Architectural Review Board Staff Report

Project Type: Amended Architectural Elevations

Description: Chesterfield Blue Valley, Lot 5B-2 (TownePlace Suites) Amended

A201

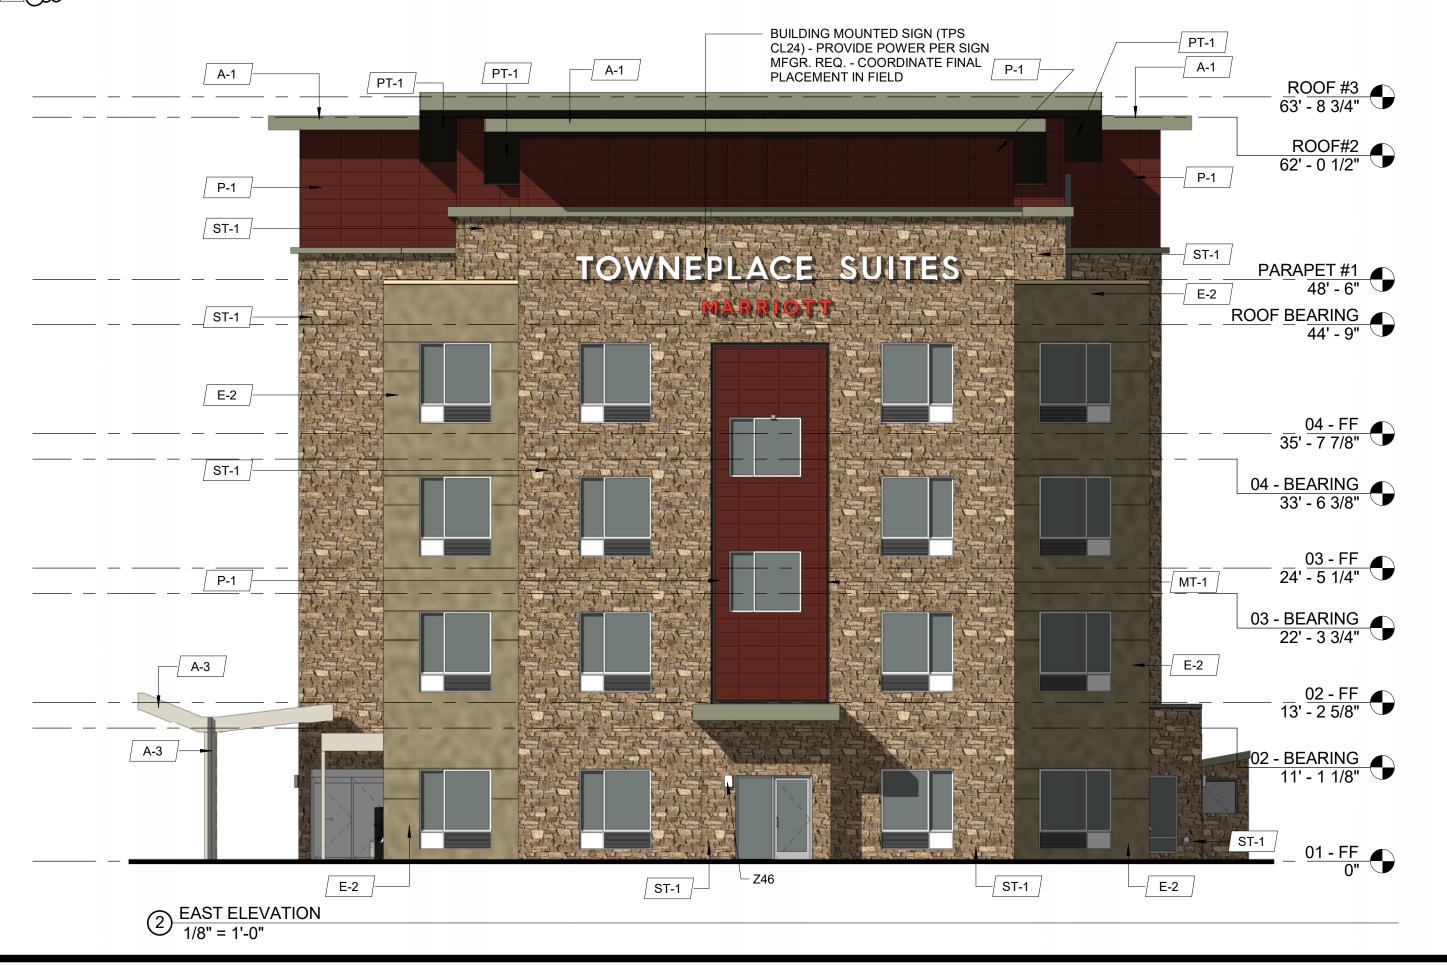
- The first request is to change the dark red fiber cement panel used in the high bay roof board panels and accent panels on the east and west elevations to 1 ½ inch thick EIFS.
 The applicant has stated the EIFS will be the same color and pattern as the originally approved fiber cement board.
- The second change requested is for a material change on the soffits. The originally approved soffits were to be fiber cement; the applicant is now proposing that these be perforated aluminum to be painted or finished in the same color, Savory Ash.
- The final request is a manufacturer change for the stone veneer on the building. This
 veneer is an accent on the ends of the north and south facades and is the primary building
 material for the east and west facades. The applicant has provided a photo of two
 different materials side by side. This photograph is located in your packet.
